REPORT TO THE DEVELOPMENT PERMIT BOARD

Agenda Item: **3.2**

Subject: File # DP 22001 Carey Theological College Expansion, Chancellor Place

Institutional/Administrative and Student Housing

North South Pedestrian Connector: Public Realm Response

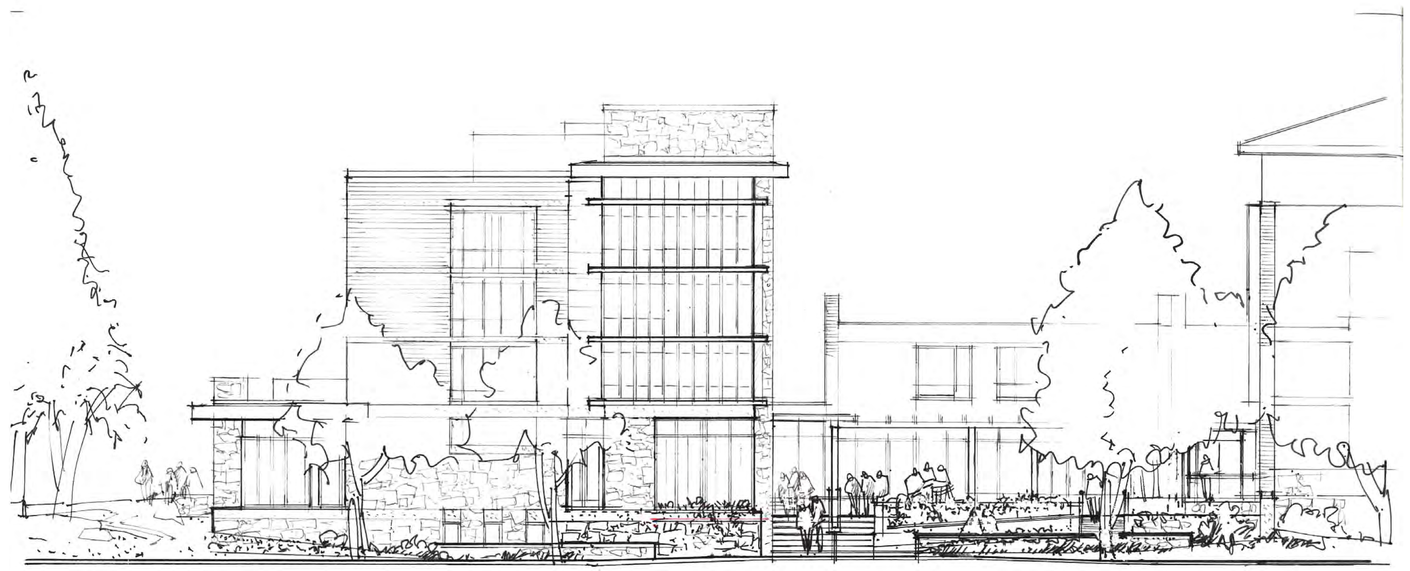
2) **That the pathway along the west property lines on Lots 40 and 42 be diverted for a portion of its length through the UNOS lands adjacent to Lot 42.**

2) **Diversion of a continuous pedestrian path along the west property line of Lots 40 and 42 .** The Requirements specify a minimum 9 foot path to run adjacent and within the property line to provide a continuous access route from Iona Drive to Walter Gage Road along the Carey College site. While a route does exist along Lot 40 to the west of Carey Centre, the path loops partially through Iona Woods west of the Lot 42 property line. Because Iona Woods is designated as UNOS (University Open Space) in the Neighbouhood Plan, the University Neighbourhoods Association (UNA) was consulted and support obtained for this route. By routing the path west of the property line, greater separation is provided from the building on Lot 42 and existing trees along the property line can be retained.

Carey is working with Campus and Community Planning (C+CP) to located an accessible path on the west side of the Carey site on the UNOS land as an overall planning objective for the east side of the Theological Neighbourhood. Carey is supportive of developing the NS Pedestrian Connector from new crosswalk at Gage Rd., through the west UNOS Land to Iona Dr., and as its contribution to the Theological Neighbourhood's system of pedestrian throughways. The experiential character of this Pedestrian Connector will be defined by the Iona Woods, located on the UNOS lands to the west and Carey's own built form edges on its own site. The experience of the Pedestrian Connector will be supported by on-site nodes and hubs starting from the centrally located "Lot 42 Café", and either continuing north to Iona Dr., or east through the site to Wesbrook Mall.

Proposed P-8 Building Height Zone Plan:

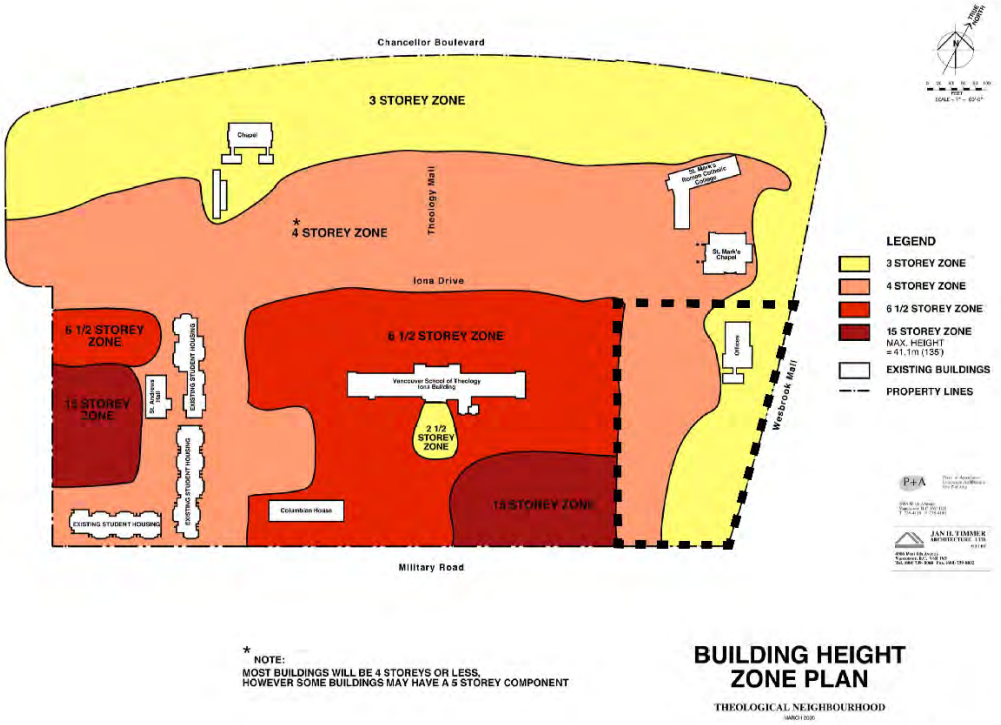
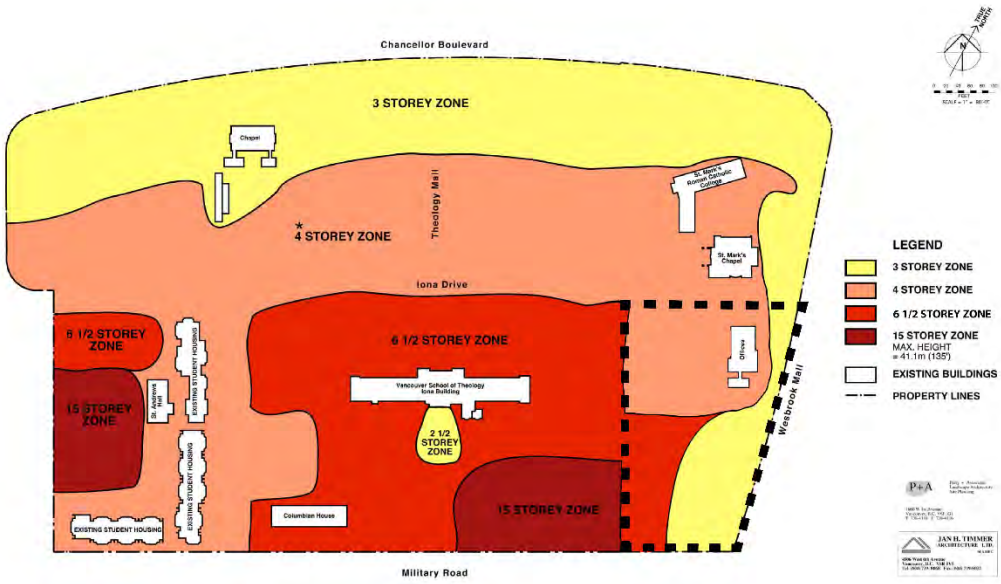
The text in Sec. 2.3.4(a) of the Neighbourhood Plan for the Carey College site was amended to permit four to 6-storey institutional buildings from the previous 5 storeys. Appendix P-8 "Building Height Zone Plan" was amended to extend the 4-storey zone eastward on Lot 40 and the 6 ½-storey zone eastward on Lot 42. Schedule P-9 "Approx.

Proposed P-9 Approx. Building Mass and Open Space Distribution Plan:

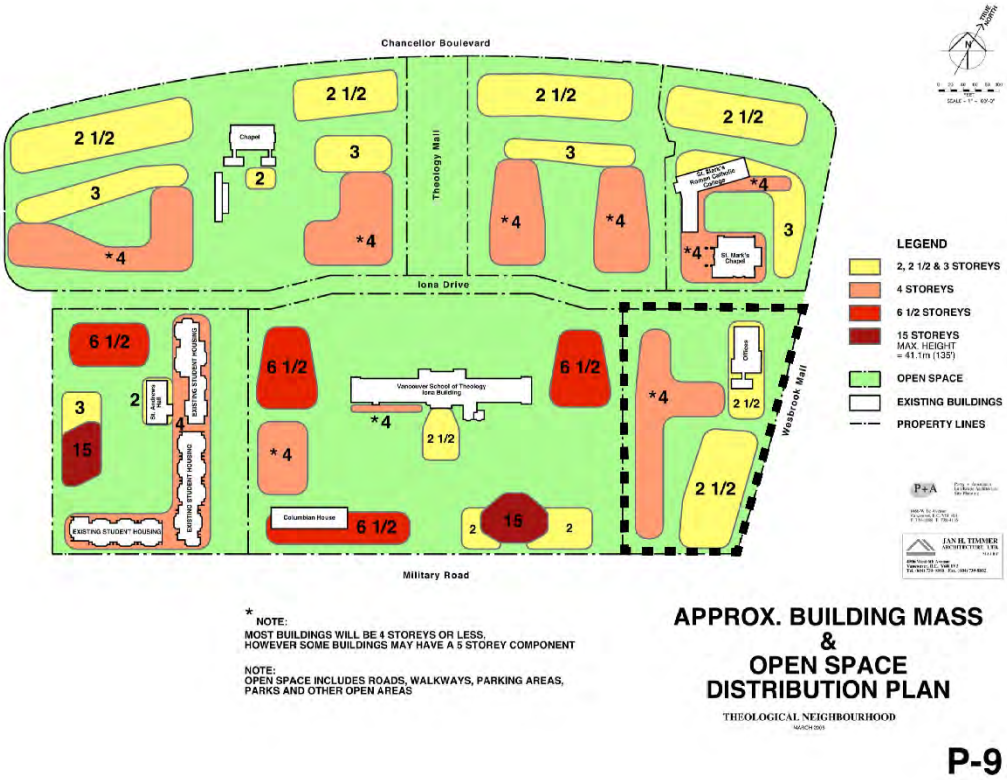
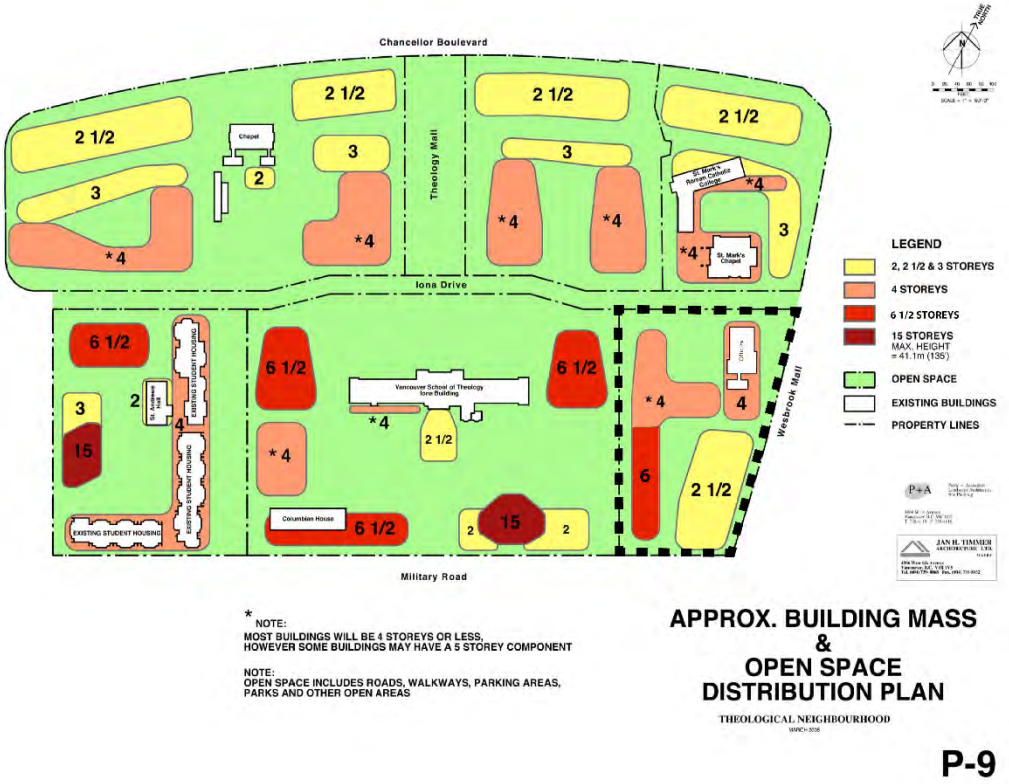
Building Mass & Open Space Distribution Plan" was amended to designate the east section of Lot 40 for 4 storey development (from 2 ½ storeys) and the portion of Lot 42 south of Carey Centre to 6 storeys (from 4 storeys). The project was already compliant with maximum heights on both Lot 40 and 42 in the Neighbourhood Plan (60 foot maximum).
